May 29, 2018
IDEA PUBLIC SCHOOLS – IDEA Brownsville Robindale Phase I

ADDENDUM NO. 2

A. PURPOSE AND INTENT
This addendum is issued for the purpose of modifying the plans and specifications for the IDEA PUBLIC SCHOOLS – IDEA Brownsville Robindale Phase I

Date: May 10, 2018
Scale: As Noted
Project Architect: David Monreal, AIA
Drawn By: ETHOS
Job No. IDEA Robindale Phase II
Sheet: E3.04

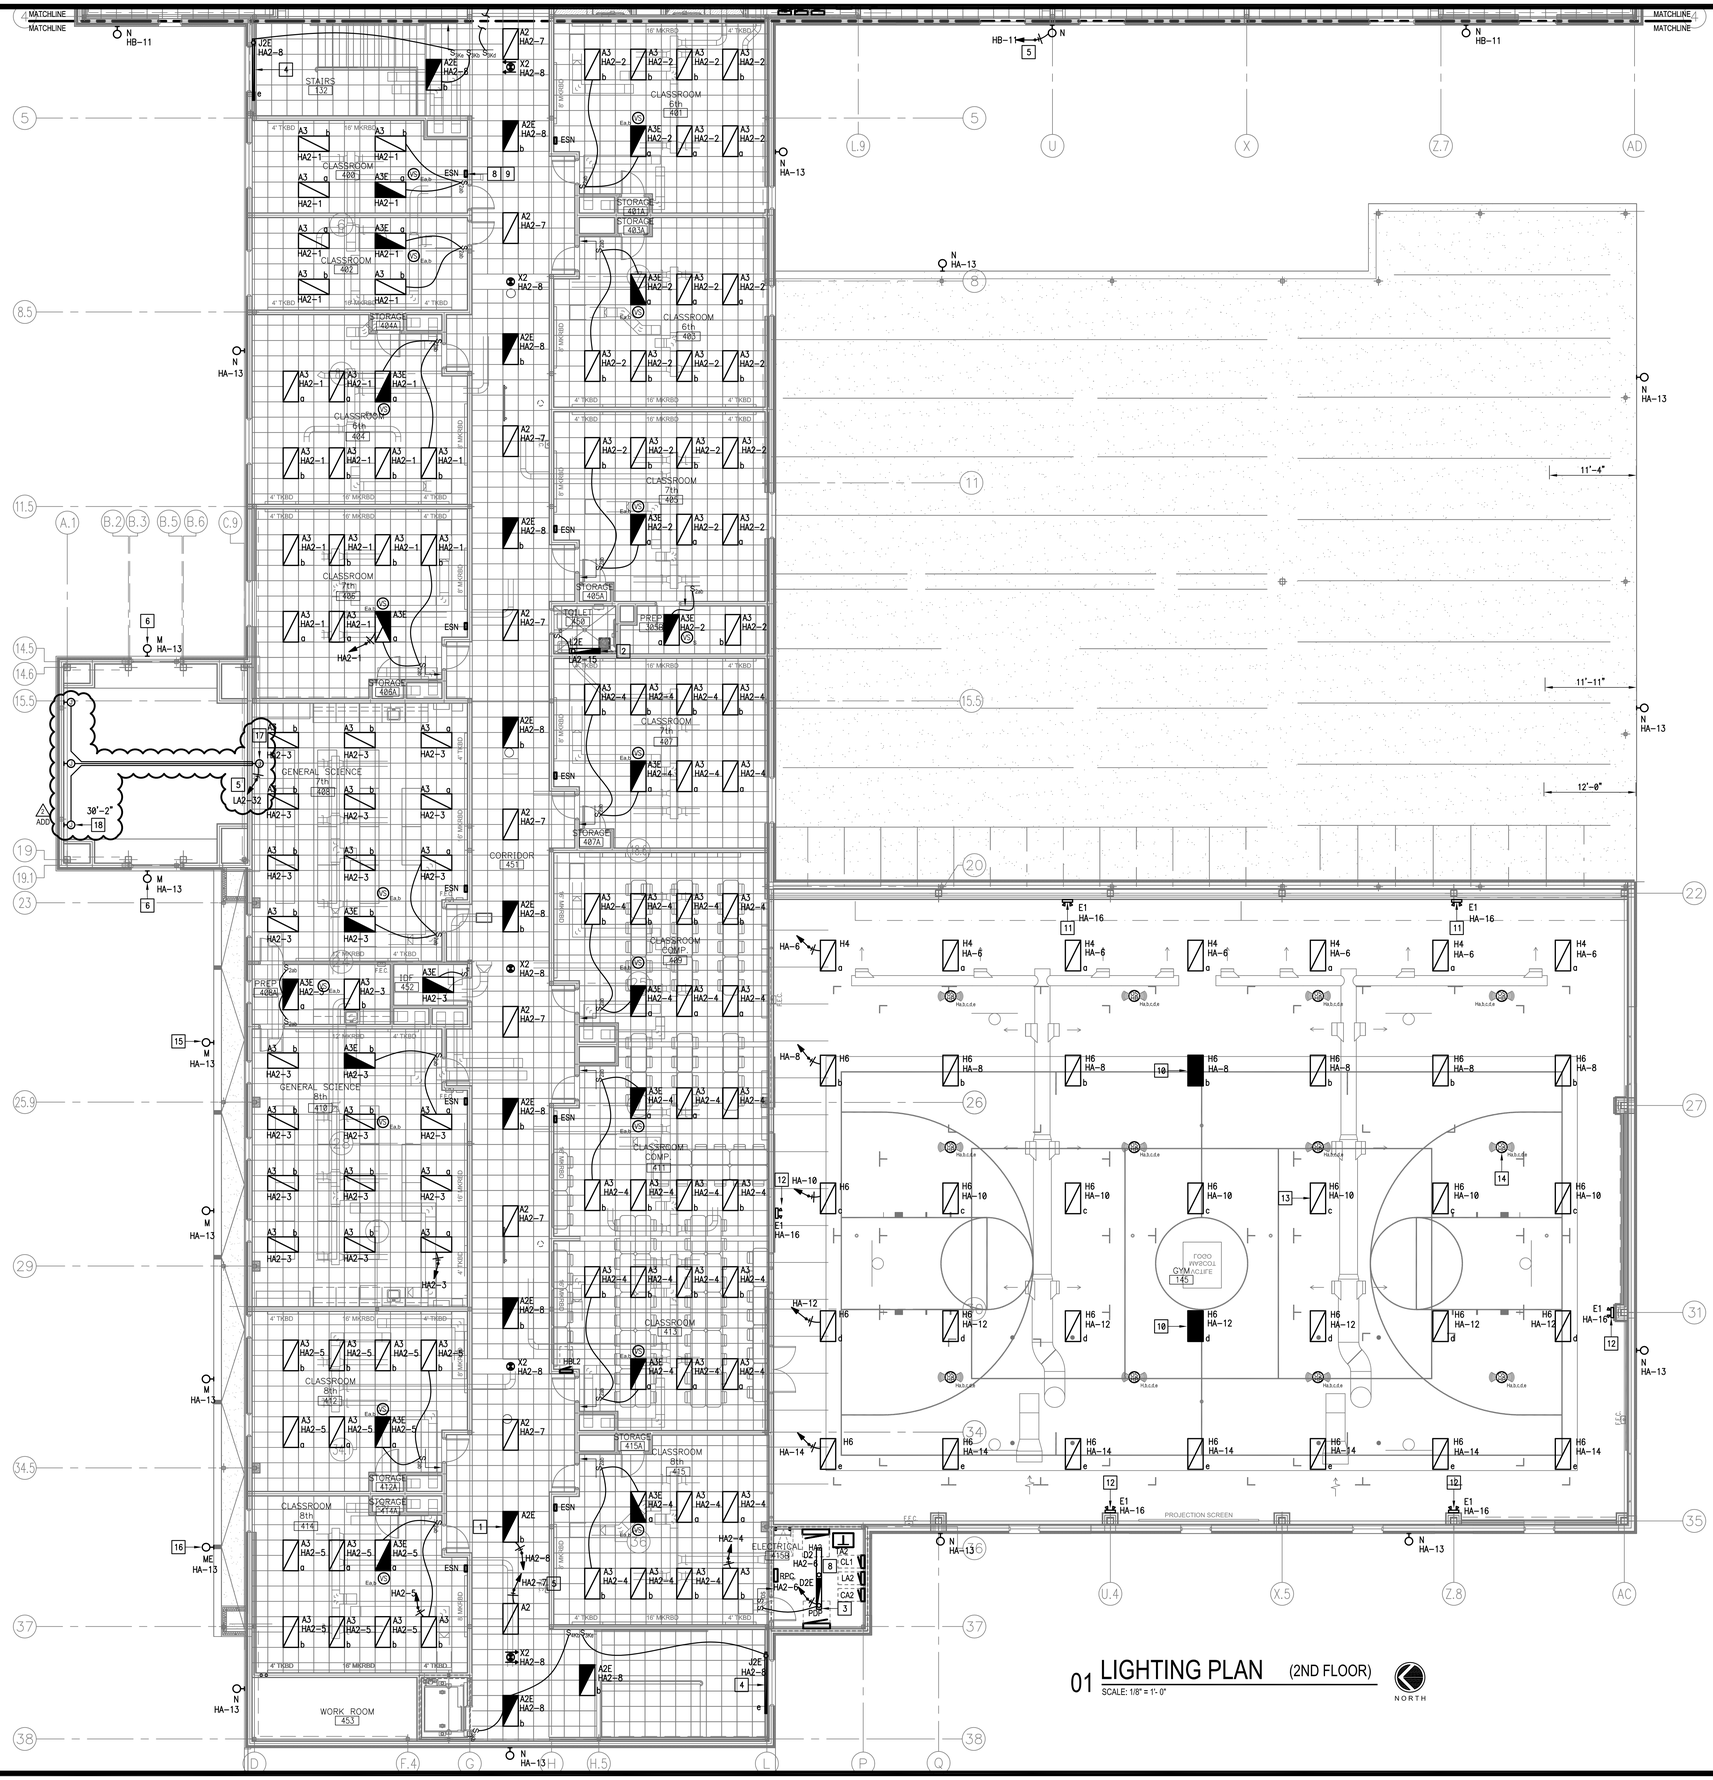
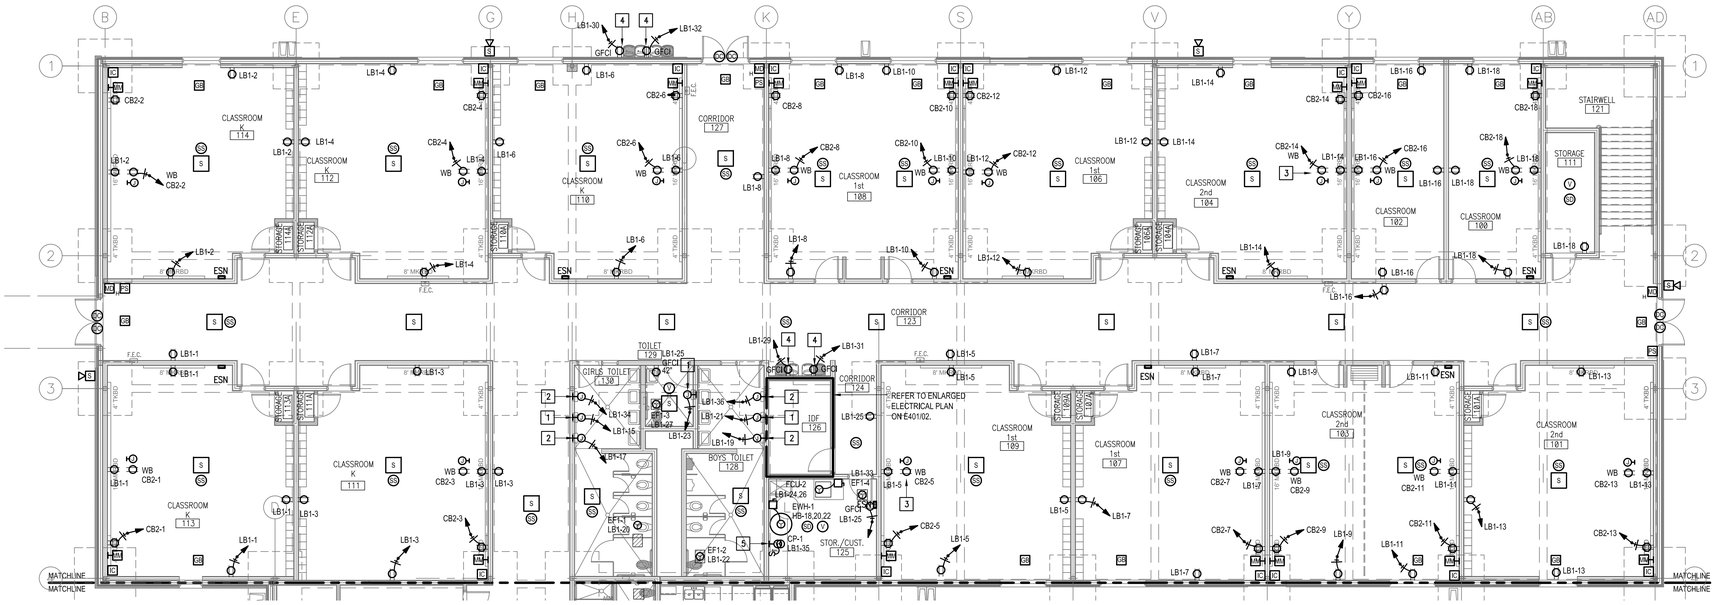
3) Sheet E3.04:
    a) Revised Second Floor Lighting Plan (Branding wall LED sign – Clarification). See attached sheet.
